STAFF ANALYSIS

Case No.:	CZ-25-1247294	File ID #: 2024-1442	
Address:	1716 Pleasant Hill Trail, 7778, 7860, 7890, 7900, 7956 & 8024 Pleasant Hill Road	Commission District: 05	Super District: 07
Parcel ID(s):	16-197-03-006, 16-197-03-012, 16-219-01-005, 16-219-01-006, 16-220-01-004 16-220-01-007 & 16 220 01 009		
Request:	Major modification of Conditions #1 and #4 of CZ-18-22130 for the development of single-family detached dwellings within the RNC (Residential Neighborhood Conservation) Zoning District.		
Property Owner(s):	Hybrass Properties, LLC.		
Applicant/Agent:	Hybrass Properties, LLC. c/o Battle Law, P.C.		
Acreage:	95.52 acres		
Existing Land Use:	Single-family dwellings/vacant		
Surrounding Properties:	North: R-100, MU-1 East: RNC, R-85 South: R-85 West: R-85		
Comprehensive Plan:	Suburban (SUB)	Consistent	Inconsistent X

Staff Recommendation: TWO-CYCLE DEFERRAL

CONCEPT PLAN
FOR
PLEASANT HILL

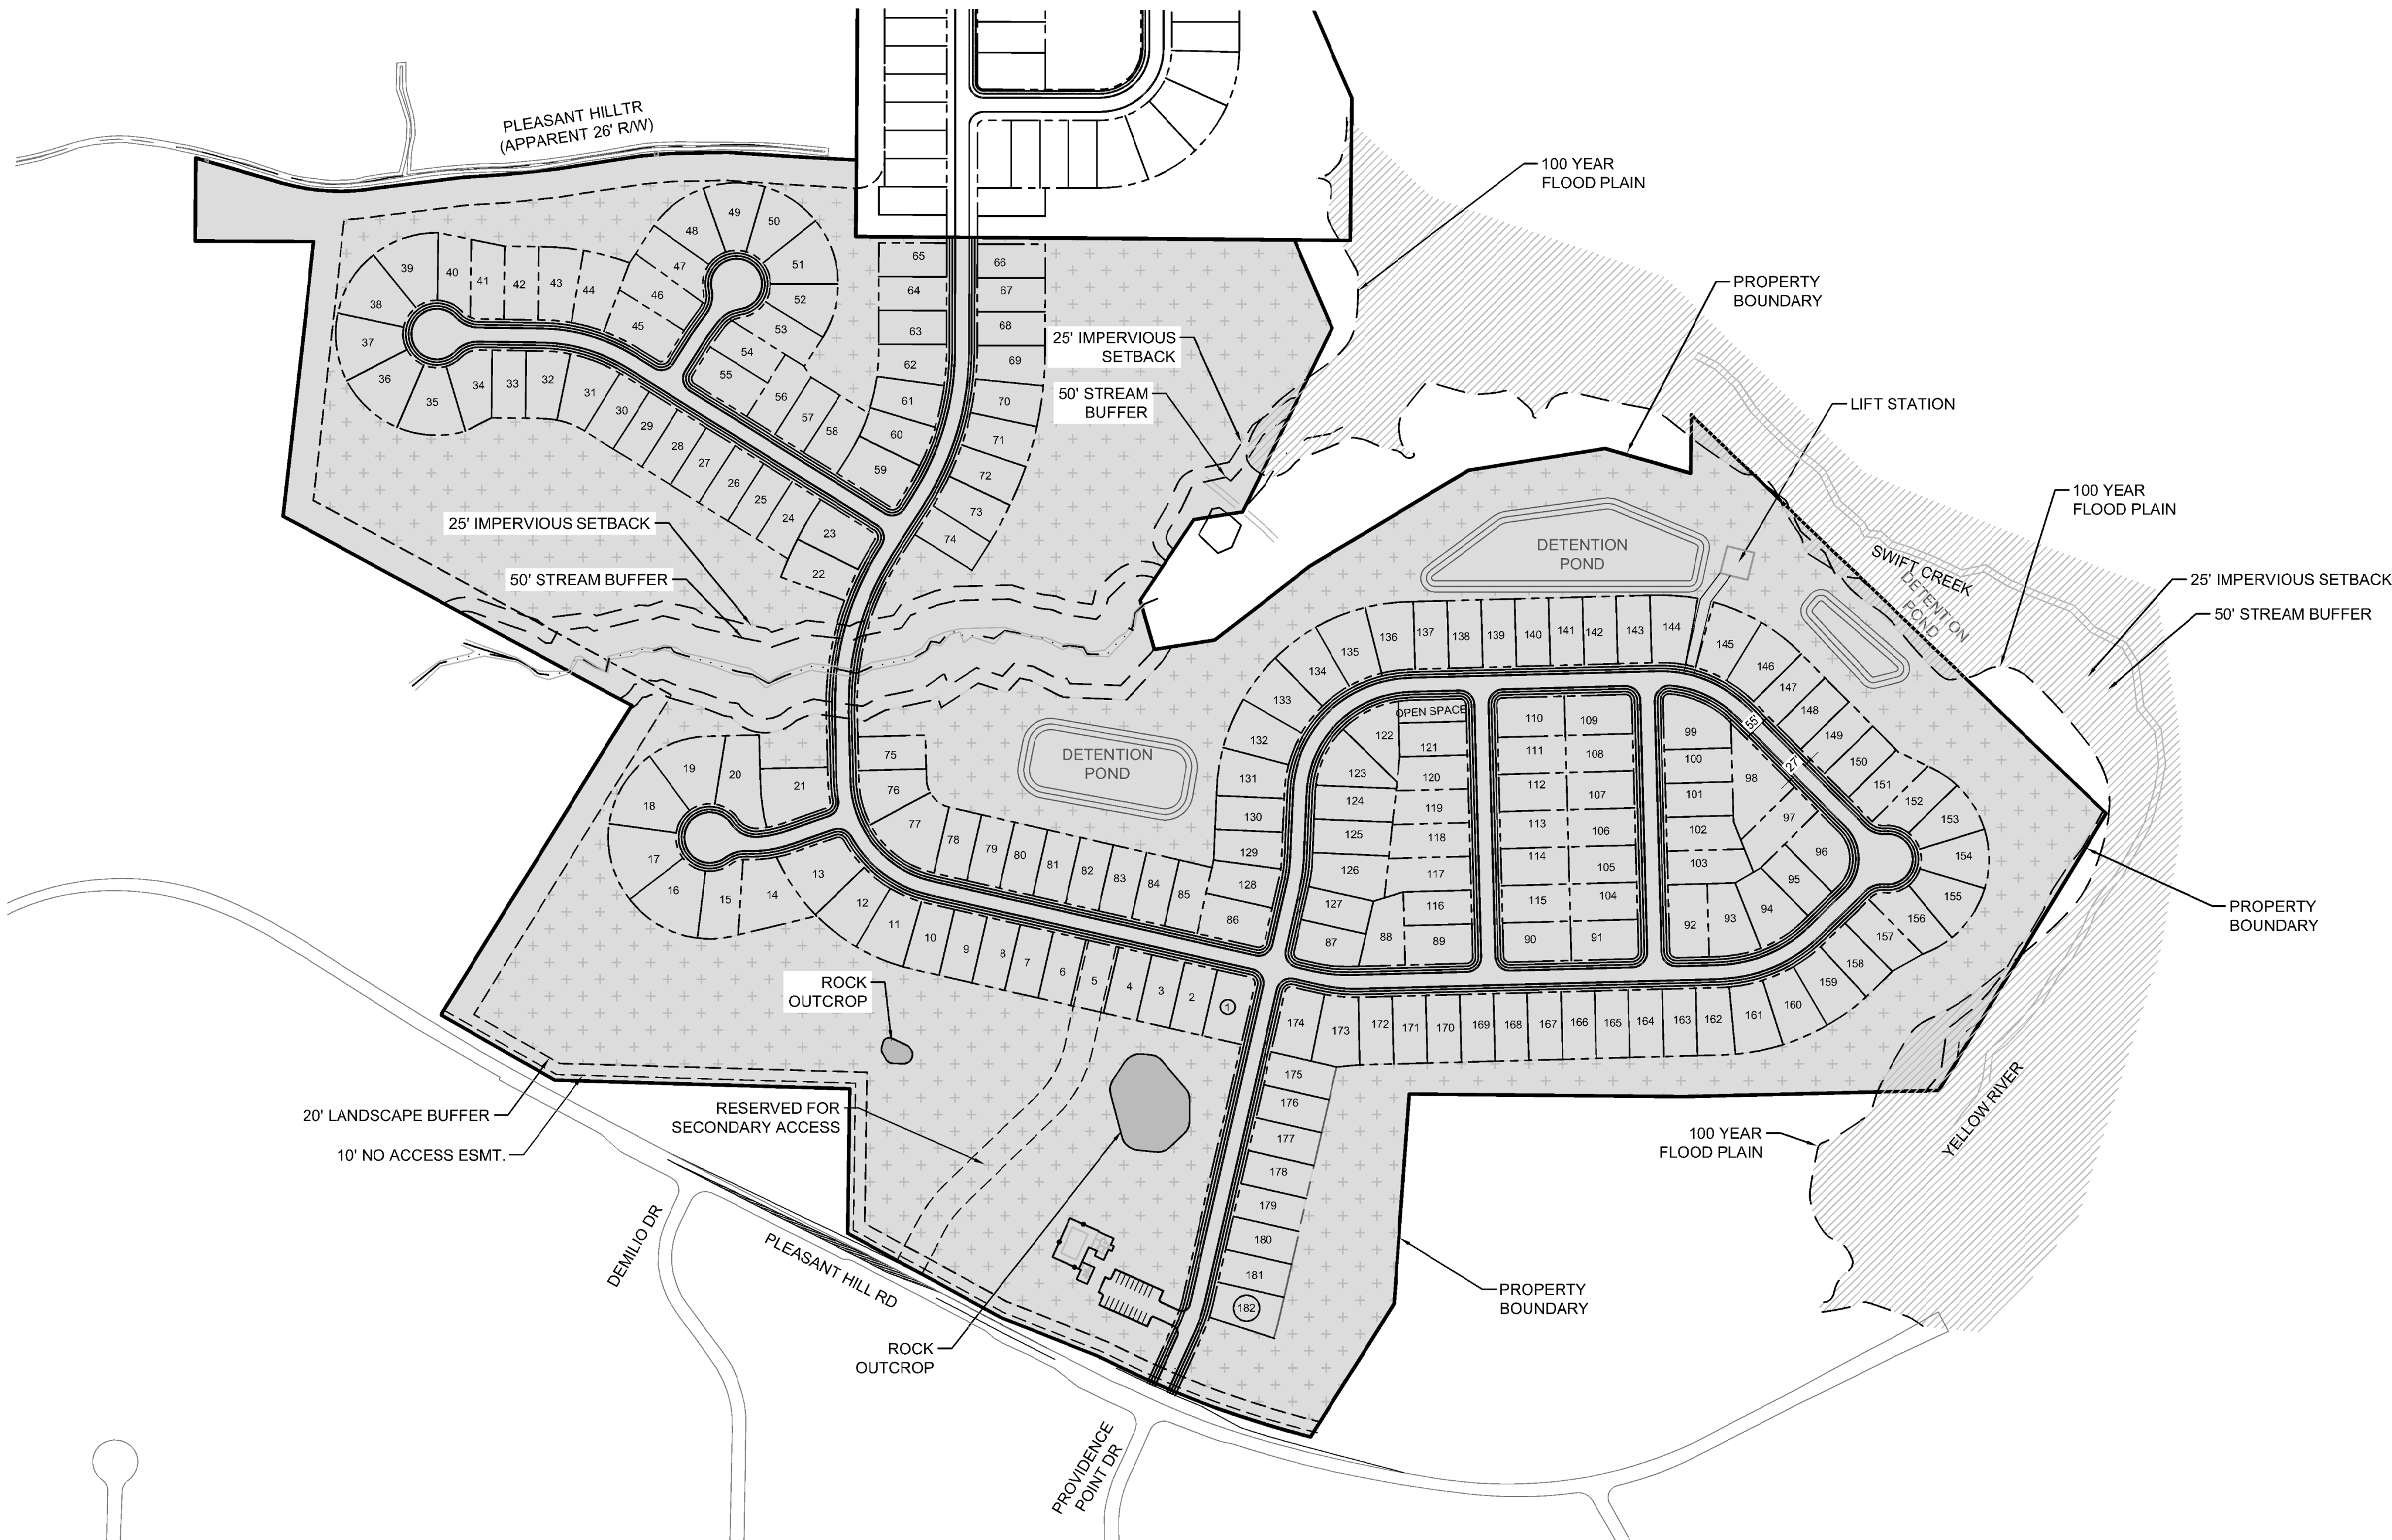
The request for a major modification of zoning conditions is a result of existing site conditions (rock outcroppings, severe slopes, etc.) that affected the implementation of the original site plan at the Sketch Plat and Land Development Permit (LDP) stages of review. A modification to Condition #1 revolves around a revised site plan (dated October 10, 2024) that reduces the number of units to no more than 182 single-family detached dwellings, a reduction of 32 units that brings the density of the proposed development to approximately 1.91 units per acre.

A modification of Condition #4 would relocate the originally proposed access points along Pleasant Hill Road to accommodate topography. One of the access points would connect to a proposed subdivision to the north of the development site; notably, however, Current Planning has yet to have received a Sketch Plat application for such a subdivision. An additional access point would be provided only for emergency vehicles. Per the current site plan, only (1) of the three (3) access points would be for regular traffic off of Pleasant Hill Road, which has raised concerns from Staff as well as the surrounding community.

While the reduction of units allows for the potential preservation of greenspace that is encouraged with RNC developments (see Section 2.10.2. of the *Zoning Ordinance*), there are still potential issues with topography that may affect the configuration and/or potential lot yield with the development. Namely, the new site plan does not appear to prove compliance with the minimum greenspace requirement as defined per Section 2.10.5. of the *Zoning Ordinance*. A minimum of 30 percent of the total site area shall be dedicated to greenspace, which may not consist of the following features (per Section 2.10.5.(B)):

The submitted site plan shows a development that appears to have extreme slopes throughout, as well as having state waters/stream buffers. Meeting this greenspace requirement could pose a challenge for development and could affect lot yield.

N5. CZ-25-1247294 - 7778 Pleasant Hills Road, etc. - Phase 1 has 182 lots and requires 3 access points (Sec. 14-200 (5)). Verify the reserved secondary access point meets the minimum spacing outlined in 14-200 (6) and has the required sight distance. Please see infrastructure requirements in Zoning Code 5.4.3 and Land Development Code 14-190. Pleasant Hill Road is a classified as a minor arterial (45MPH). Requires a right of way dedication of 40 feet from centerline OR such that all public infrastructure is within right of way, whichever greater. Requires at least an 11-foot travel lane with curb and gutter. Requires a 10-foot landscape strip (with at least 5 feet between the back of curb and the sidewalk/path), 6-foot sidewalk with 4-foot bike lanes OR (preferred) 10-foot multiuse path in lieu of sidewalk and bike lane. Street Lighting required. (hefowler@dekalbcountyga.gov). Pleasant Hill Road is classified as a local road. Requires a right of way dedication to 27.5 from centerline OR such that all public infrastructure is within right of

As a result of meetings with Current Planning Staff, the applicant has requested a deferral of the proposal to revise their site plan and provide additional information. In coordination with the applicant's request, the Planning and Sustainability Department recommends a *Two-Cycle Deferral* to address the above issues.
